Dominion Supplemental Projects

Transmission Expansion Advisory
Committee
December 12, 2019

Dominion Transmission Zone: Supplemental Evergreen Mills 230kV Delivery - DEV

Need Number: DOM-2018-0001

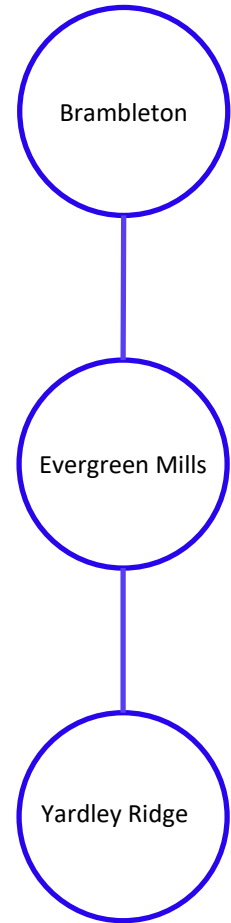
With the total projected load exceeding 100 MW, two transmission sources will be required to comply with the Company's Facility Interconnection Requirements and avoid a violation of mandatory NERC reliability criteria. Cut and extend Line #2172 (Brambleton-Yardley Ridge) into and out of new Evergreen Mills Switching Station which will be constructed with four (4) 230 kV breakers in a ring bus arrangement.

The customer has requested two (2) additional 230kV breakers to be installed for additional redundancy and will be responsible for excess facilities charges. Estimated excess facilities charge for two breakers is \$1.8M.

The previously presented solution was modified due to decreased Customer load projections.
